**FOLDING
BLEACHER
REPLACEMENT
& RELATED
WORK FOR MSD
LAWRENCE
TOWNSHIP**

DRAWING
LAWRENCE NORTH HIGH SCHOOL
UNIT "A" AND "B"
ELECTRICAL FLOOR PLANS

GIBALTAR DESIGN
ARCHITECTURE • ENGINEERING • INTERIOR DESIGN
AD. 01-5

STAFF - UNIT "B" ELECTRICAL SECOND FLOOR PLAN
SCALE: 1/8" = 1'-0"

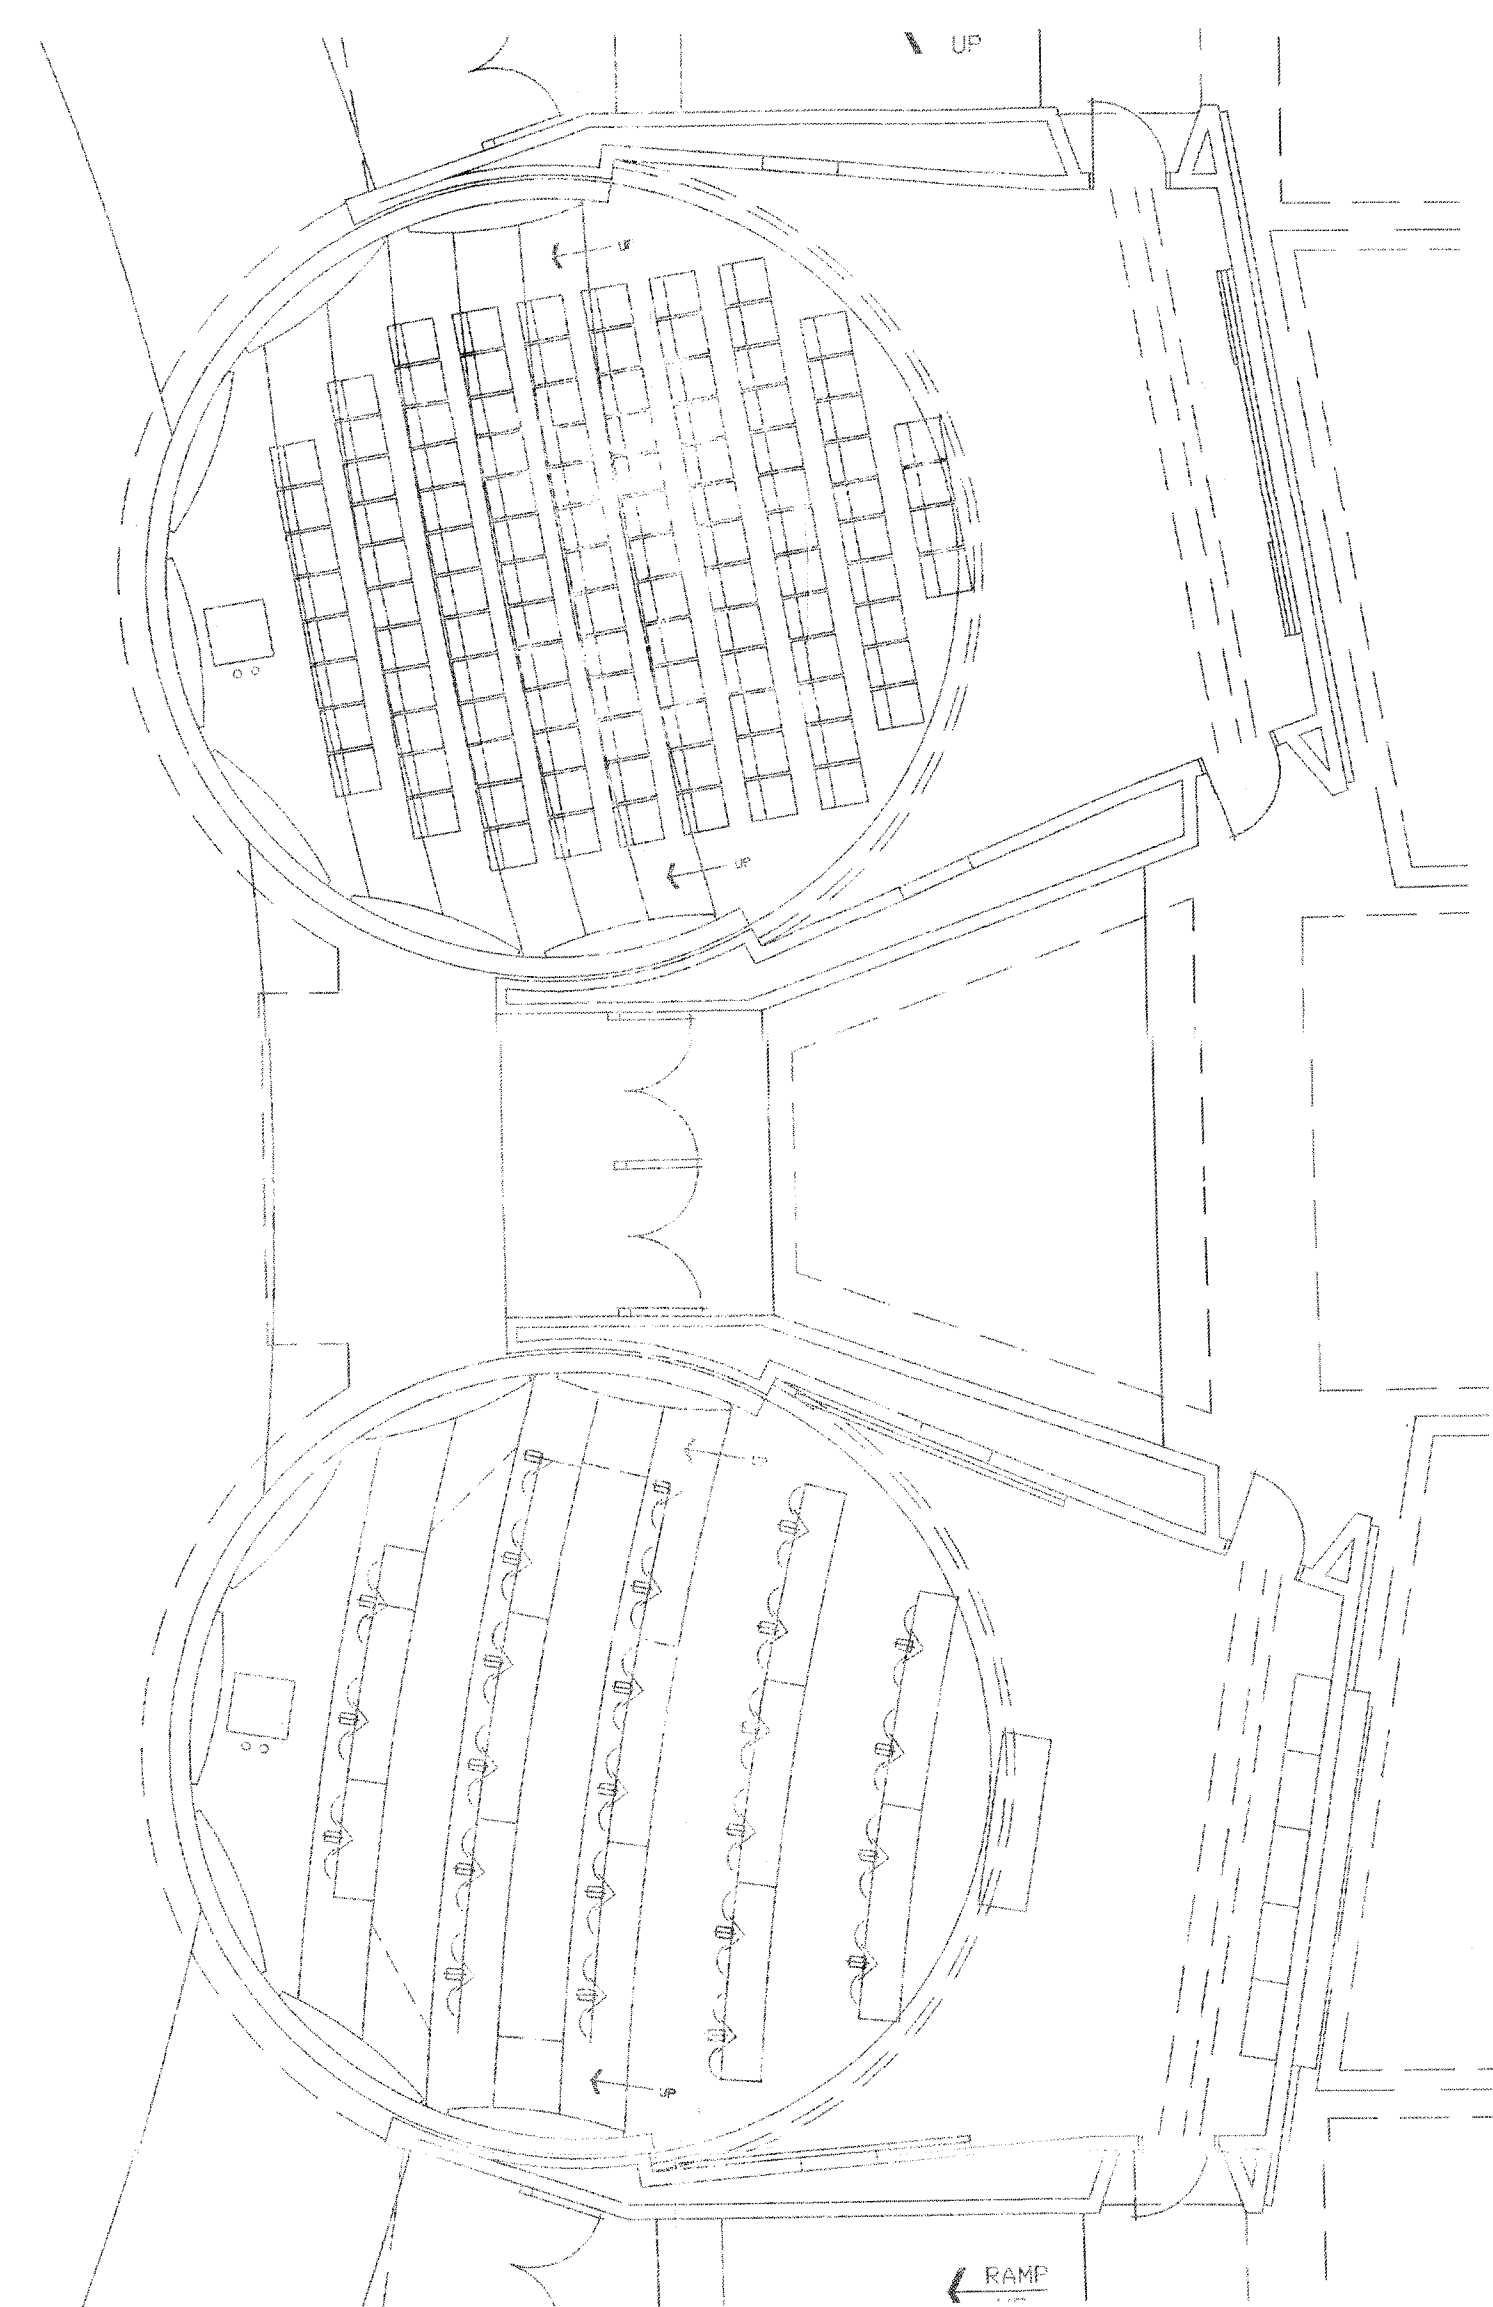
- A. Plan Notes:
- Revise Plan Note 1 to read as follows: "Remove existing louvered cover panel (McPhibin Model #93-05A) with internal glass lens. Remove glass lens, protect and store for reinstallation. Straighten bent cover plate as much as possible. Clean cover plate with solvent and #000 steel wool. Clean and reinstall glass lens. Replace existing lamps with new type T-10, 130 volt, 40 watt clear lamp. Reinstall cover plates on existing fixtures after installation of carpeting is complete. Properly dispose of removed lamps."
 - Revise Plan Note 2 to read as follows: "Add one (1) 1' x 4' grid mounted fluorescent light fixture with earthquake clips in Entry as indicated. Fixture to have 0.150 inch thick #12 pattern acrylic lens, two (2) 32 watt T-8 lamps, and one (1) 277 volt electronic ballast. Fixture to be Daybrite Model 1DG232-FS19-277-1/2-EB, or equal."

- B. Revise location of fire alarm notification appliance strobe light in new hallway north of B-202 to east wall as shown on attached drawing.
- C. Delete telephone outlet on east wall of B-202 as shown on attached drawing. Voice/data outlet shown on east wall of B-202 to contain one (1) voice jack and one (1) data jack. Refer to Specification Section 16742 included in this Addendum.
- D. Add "Existing IDF" designation to closet located to the southwest of renovated area in Unit B. This IDF serves area to northeast and B-202.
- E. Add a fire alarm notification appliance strobe on the east wall of the new room to the north of the existing IDF as shown on the attached drawing.
